Product/Process Change Notice (PCN)

PCN #: ConMJ_20140711
Product Affected: 615008138021
Effective Date: 2014-11-01

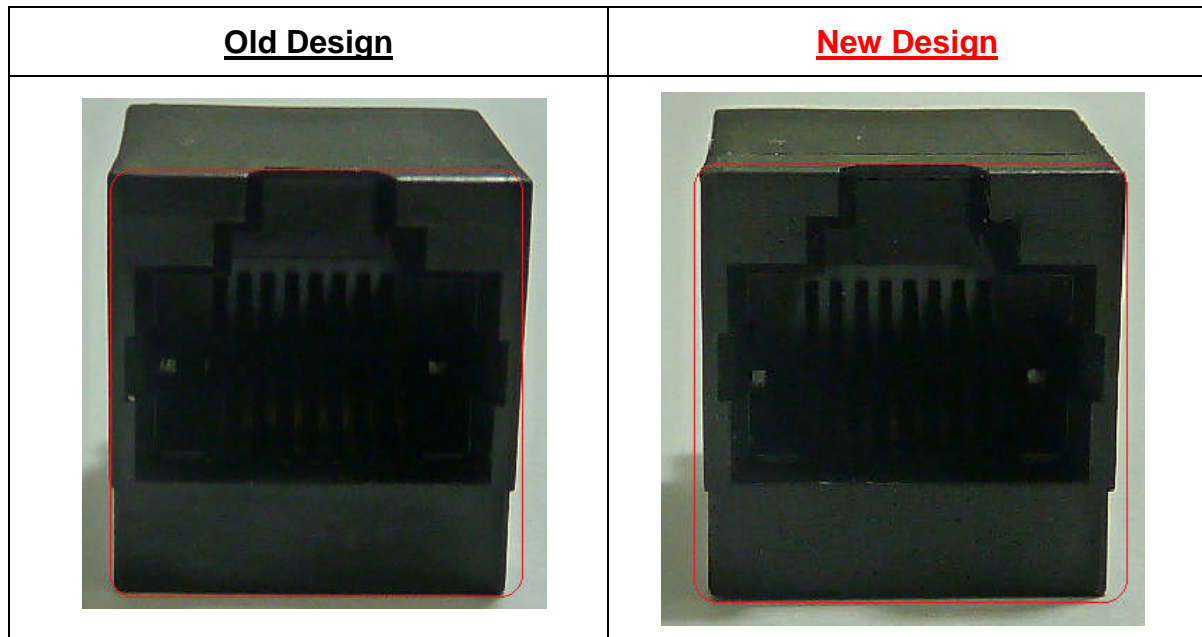
With the new tooling the surface design is matted to prevent scratches. All dimension, electrical, and mechanical properties remain the same.
